Site Formation and Infrastructure Works for Police Facilities in Kong Nga Po - Design and Construction

Detailed Landscape Design Report (Revised Final Rev. 4)

Contract No. NDO/02/2018
Site Formation and Infrastructure Works for Police Facilities in Kong Nga Po
Landscape and Visual Mitigation Plan

Response to Comments

Drawing No.: 60534575/ACABAS/017

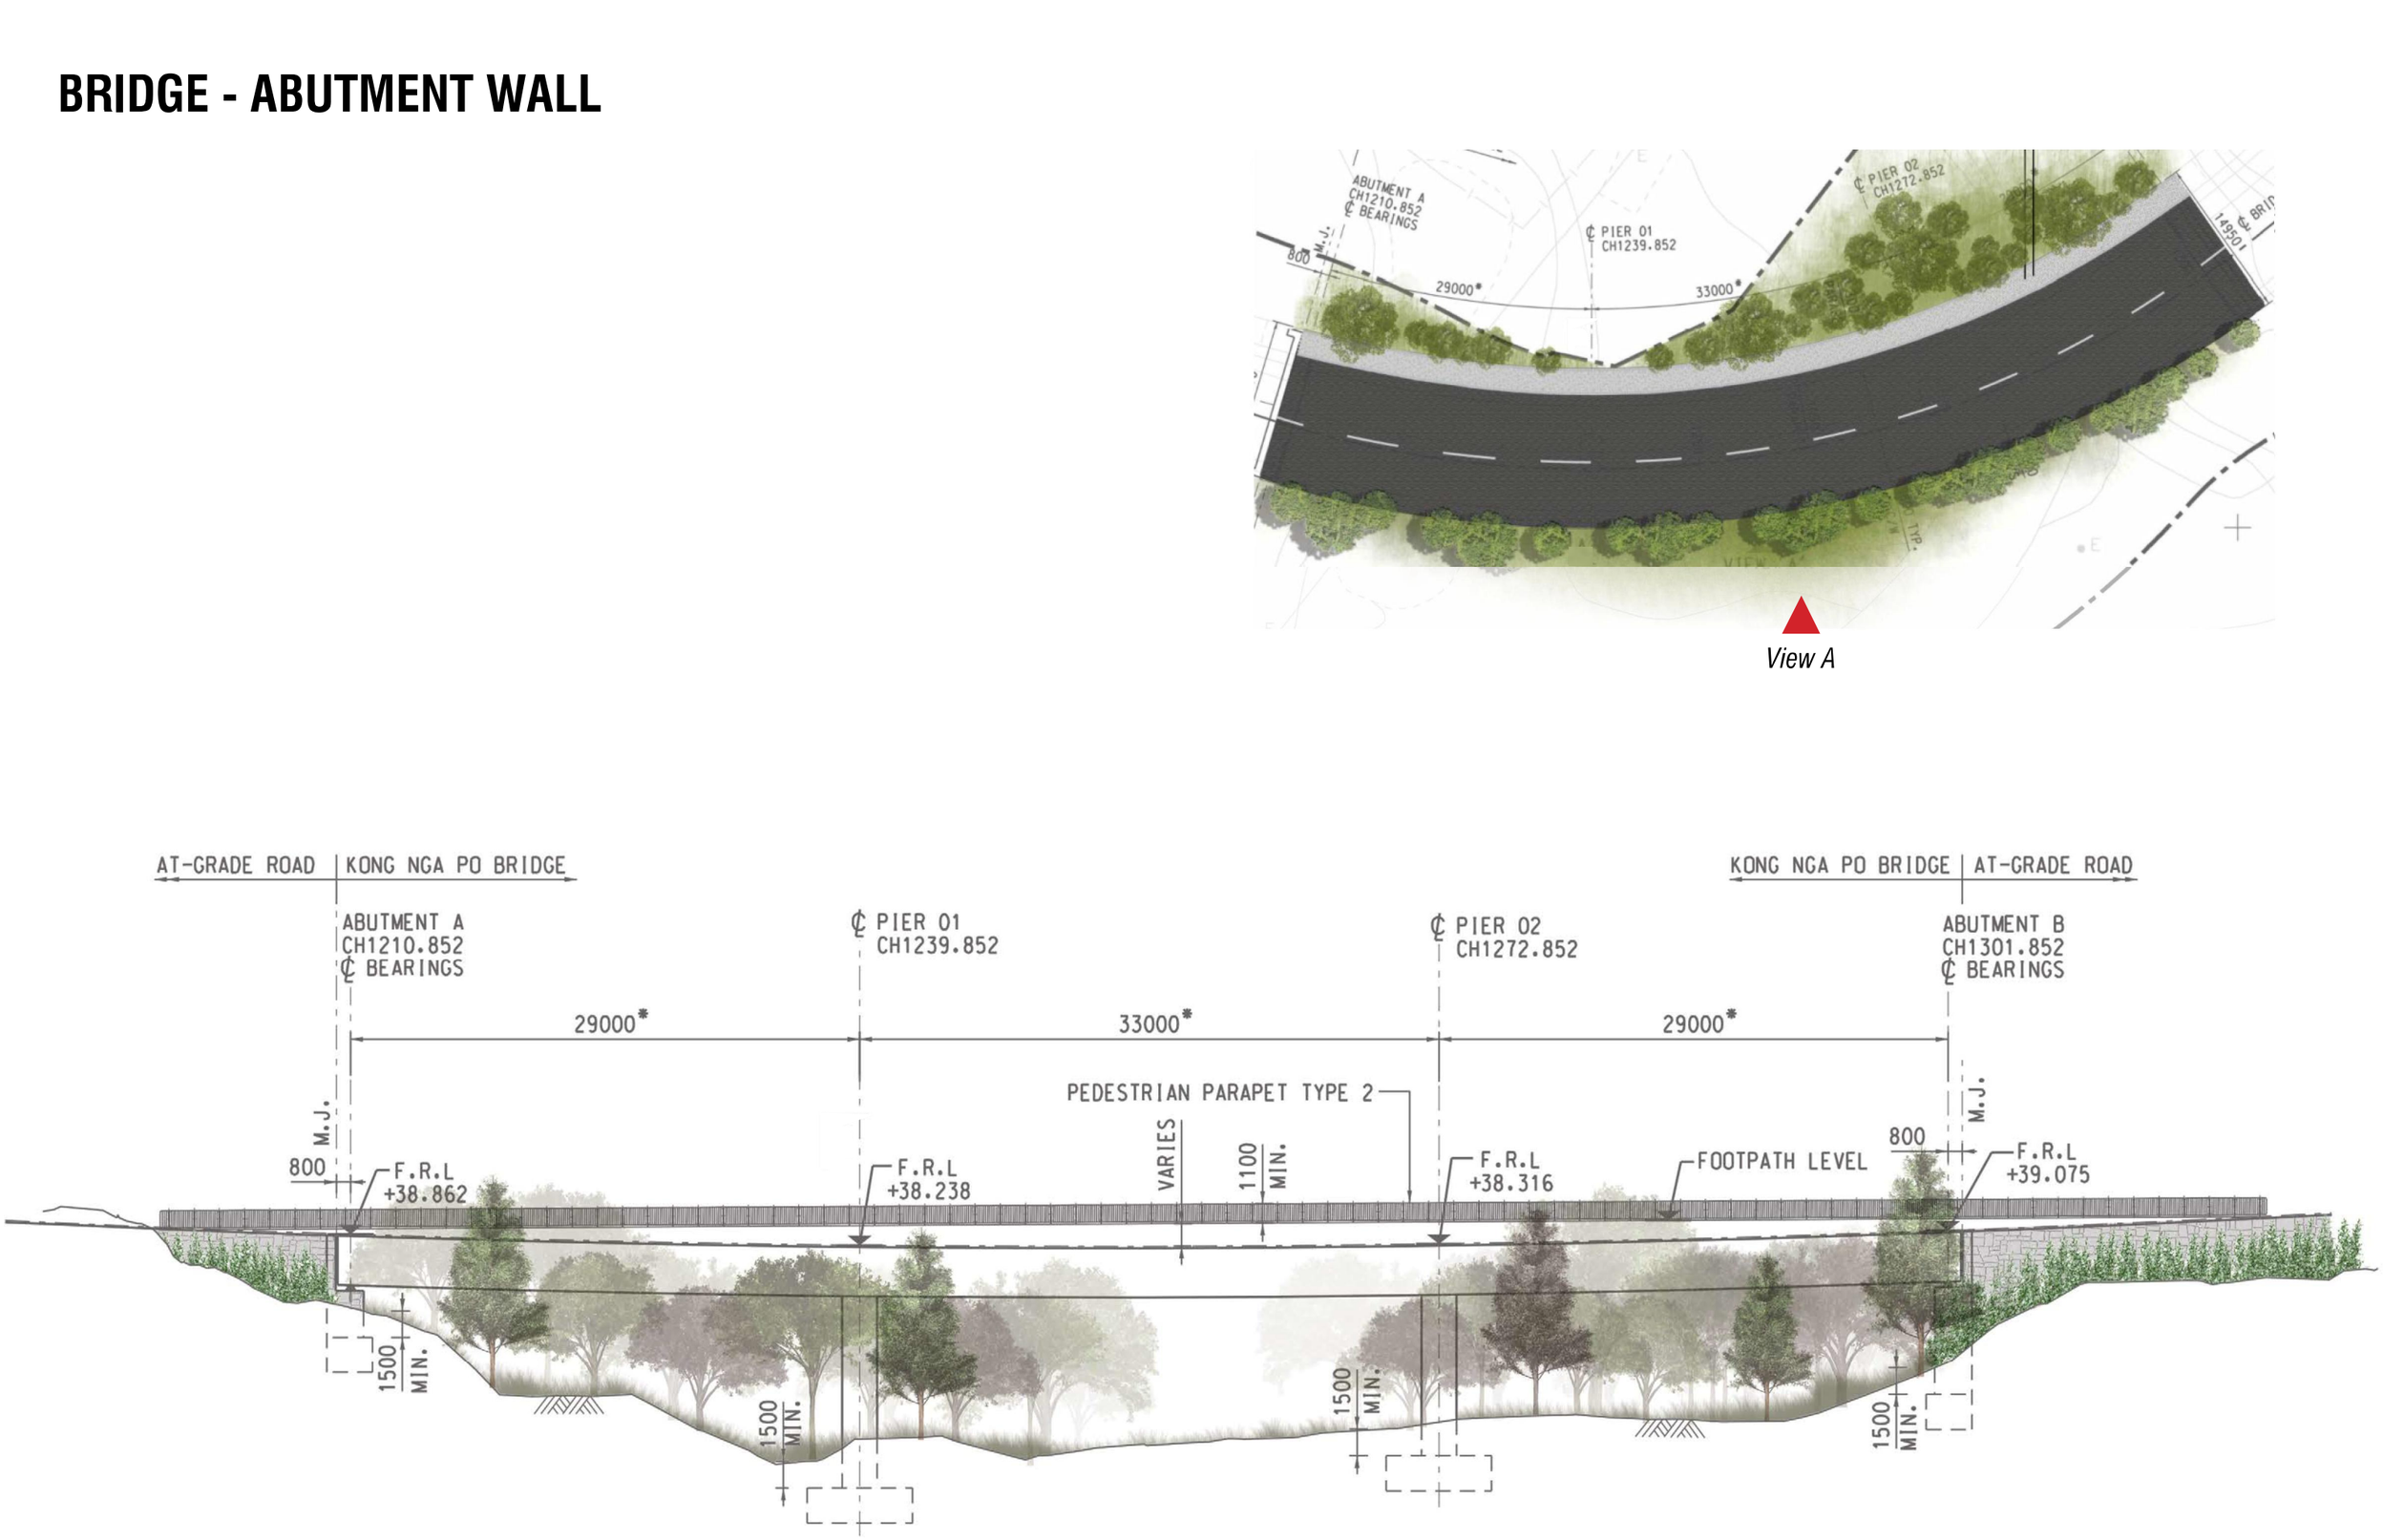
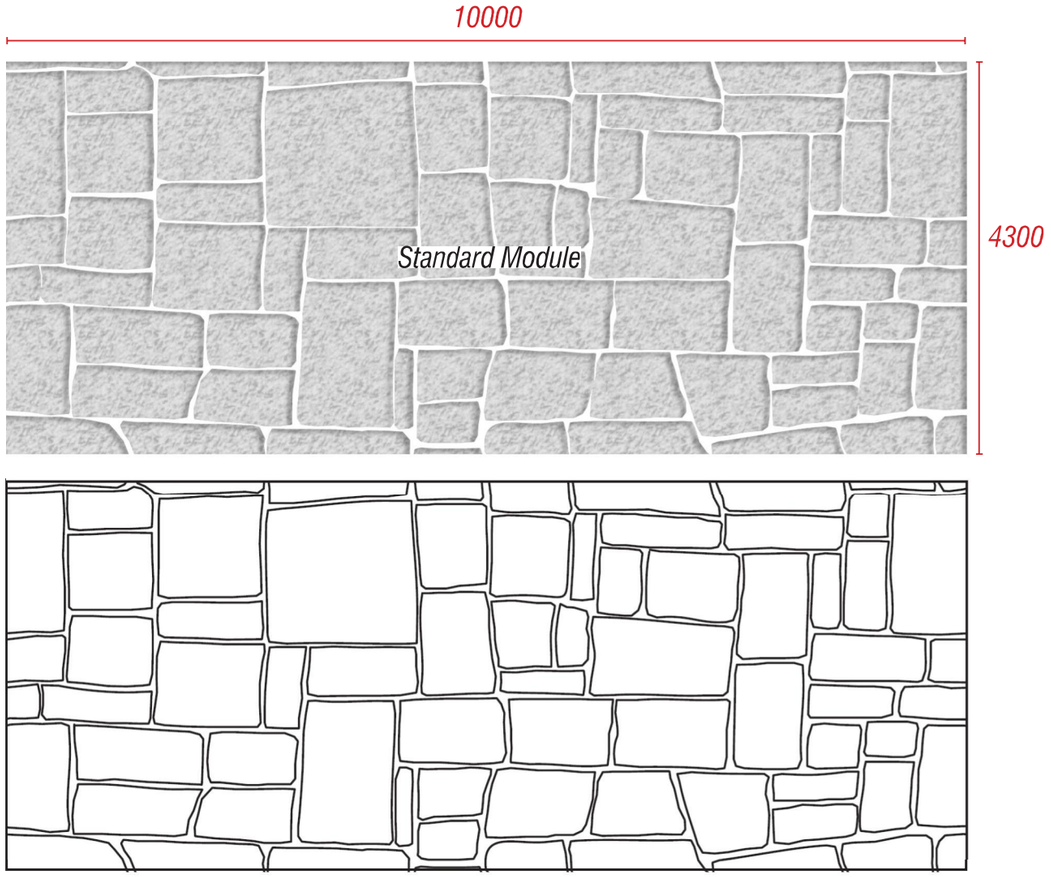
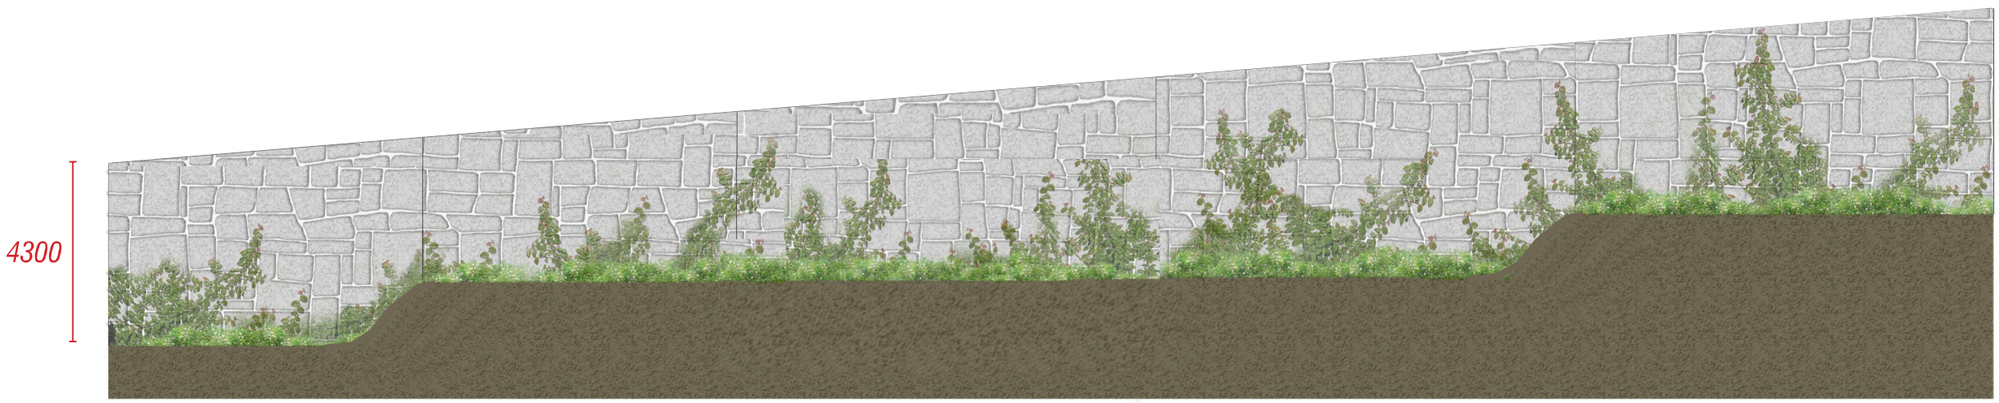
m) The hard landscape treatments are inconsistent to the ACABAS submission. Updated hard landscape treatment should be submitted for comment.	Noted and updated. The updated treatment is shown in Appendix II.
